MEETING MINUTES DAG MEETING #3

Project Name: Portland Public Schools - Kellogg Middle School Replacement
Date & Location: 11/07/17 @ Franklin High School
Prepared by: Tim Ayersman
Present: DAG: (*: Present, A: Absent)

MEMORANDUM

Subject: DAG #3 Site Questions Results
 Prepared by: Samantha Aleo
 Distribution:

Question 1: Should the parking be closest to the entrance? **Majority response: Yes, 16 : 2**

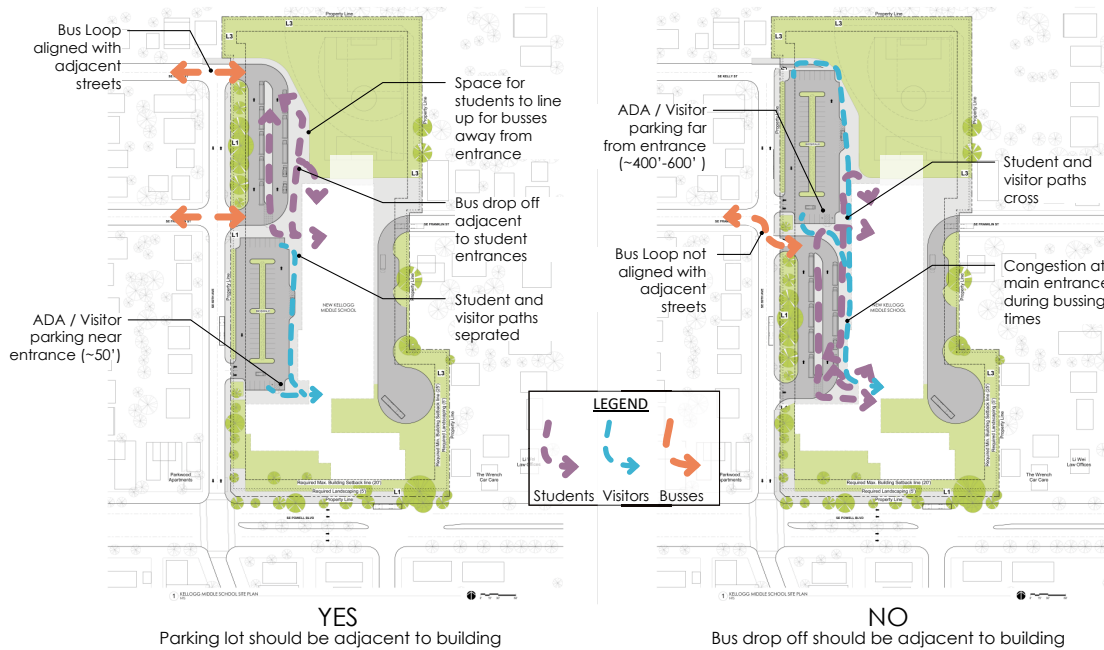
- Seems safer for students/pedestrians
- Better security for cars

- Busses should be let off closest to the entrance
- Poor lines of site from main entrance to bus loop

Question 3: Should the deliveries be from SE Franklin St? Majority Response: Yes, 17 : 0, 1 undecided

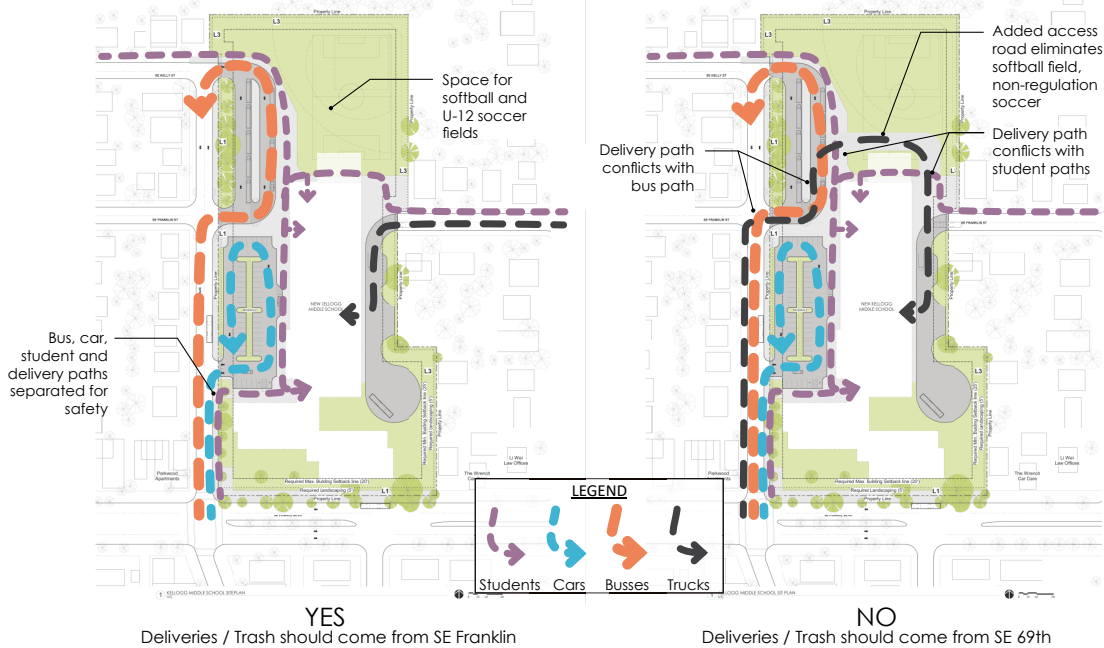
- safer, out of the way of kids/pedestrians
- deliveries do not occur frequently enough to warrant neighbor concern

- desire to revisit the use of Franklin access space in relation to neighbors
- consider deliveries only after 6am

Question 4: Should bike parking be distributed on the site? **Majority Response: Yes, 15 : 2, 1 undecided**

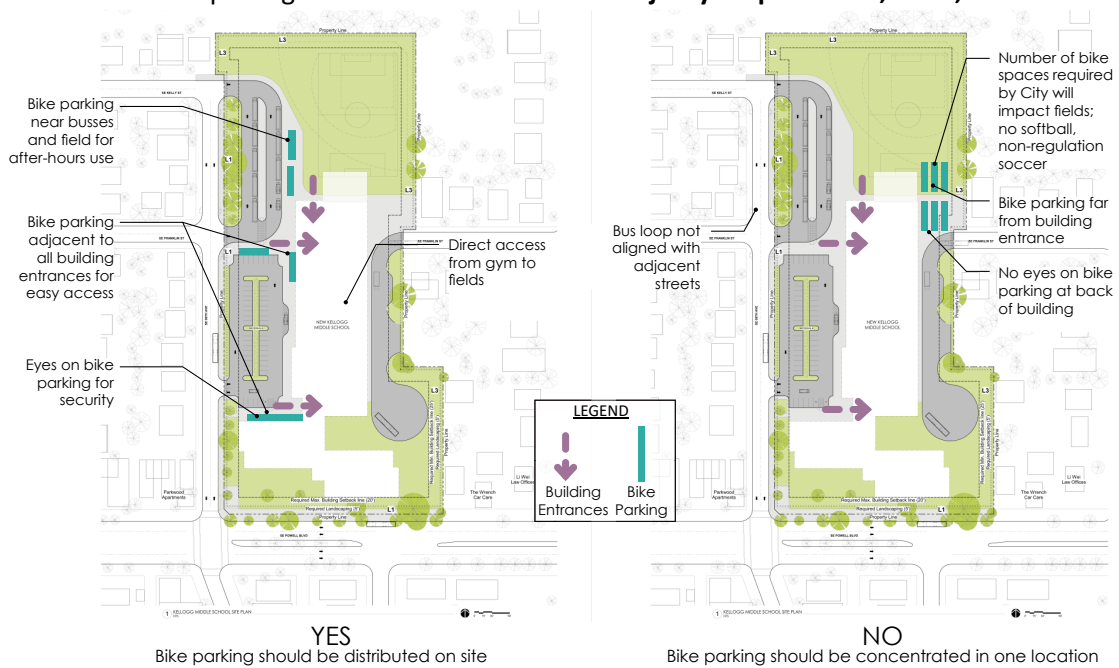
- better visibility from administration
- allows after hour use
- concentrated location makes theft easy

- consider additional distributed and condensed locations
- concentrated bikes could be gated off
- option for security cameras in one location

Question 5: Should the classroom wings step on Powell? **Majority Response: Yes, 13 : 2, 3 undecided**

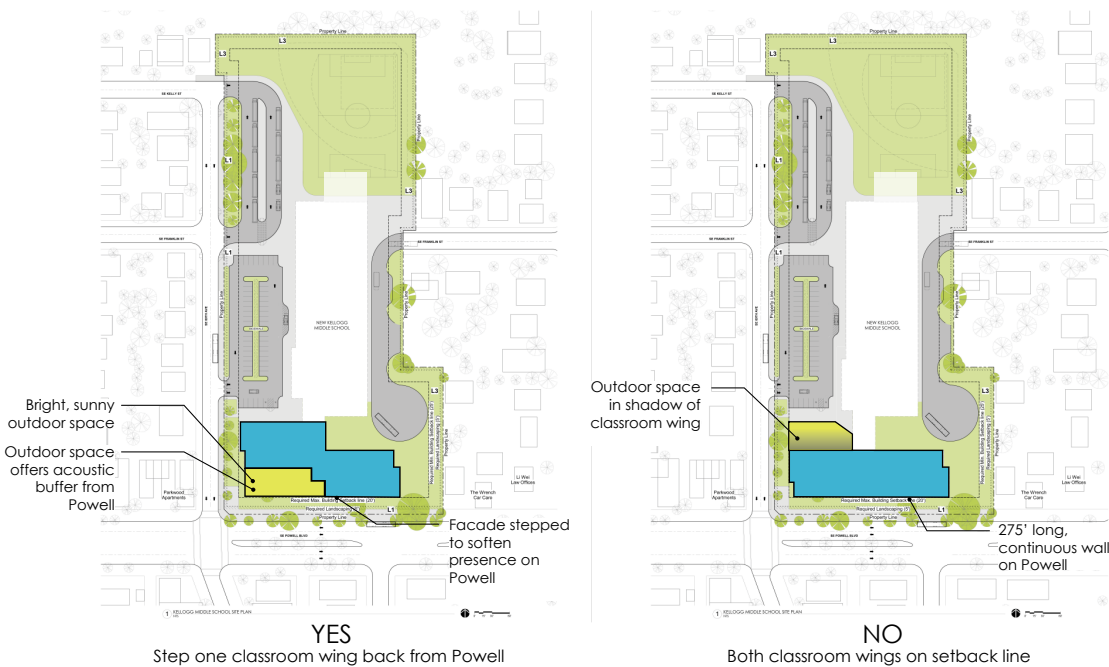
- fenced off space provides great opportunities
- great sun exposure for outdoor learning and gardening
- maximizes use of outdoor space

- unsure about air quality from Powell
- concern about noise level from Powell inhibiting education
- aligned wings could allow opportunity for a creative connection or atrium location

Question 6: Should the classroom wings on Powell be 4 stories? Majority Response: Yes, 17 : 0, 1 undecided

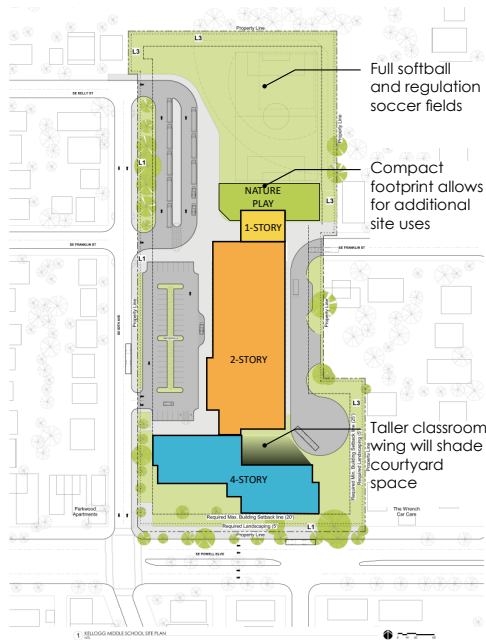
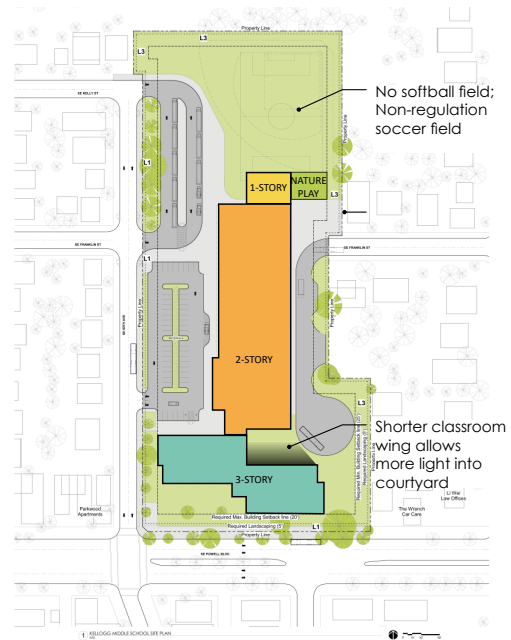
- more cost effective
- more energy efficient
- allows for more outdoor space and regulation fields

- explore option for one 3 story wing and one 4 story wing

Question 7: Should the play structure be on the ground? Majority Response: Yes, 15 : 1, 1 undecided

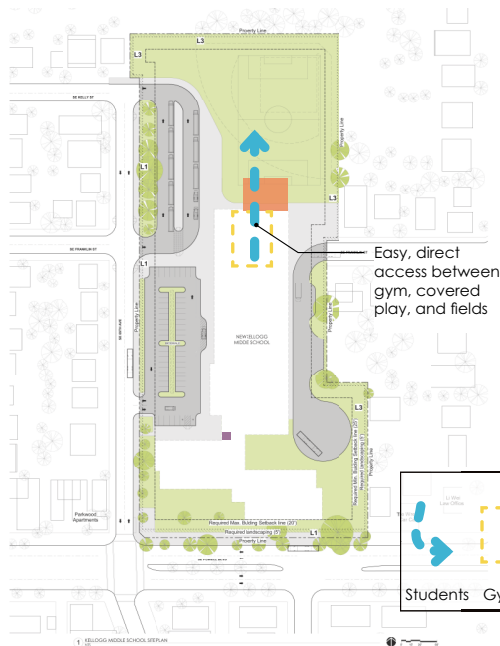
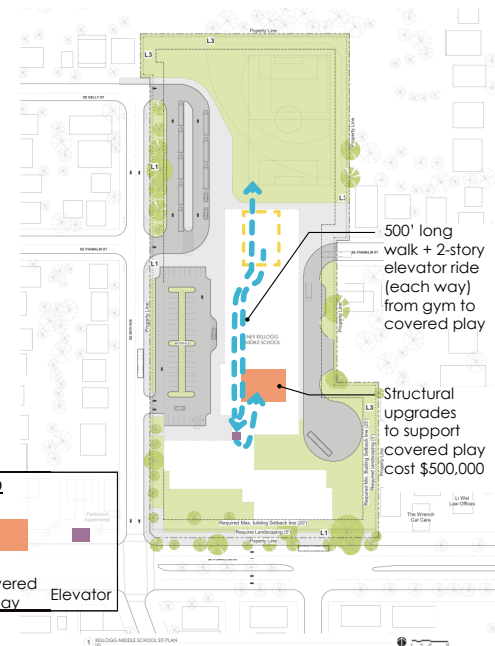
- allows community access after hours
- safer, better ADA access

- consider alternate rooftop option such as garden / green roof
- cost prohibitive

Question 8: Should the courtyard on Powell be dedicated to educational use? **Majority Response: Yes, 15 : 1, 2 undecided**

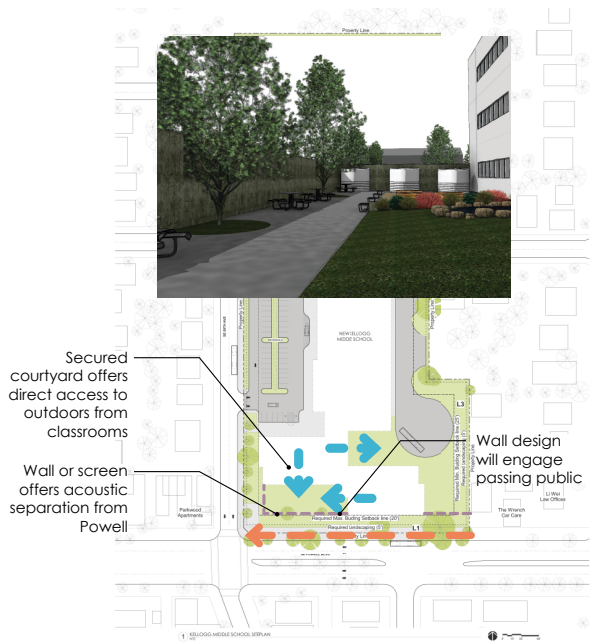
- fencing off the space creates a nice learning environment, free from litter and debris
- opportunity for outdoor summer lessons
- keeping an open, public courtyard could attract homeless / transients, traffic issues

- would love to incorporate the community
- enclosing with fences makes the school inaccessible to the community, not as welcoming
- concerns about managing students outdoors near the busy streets
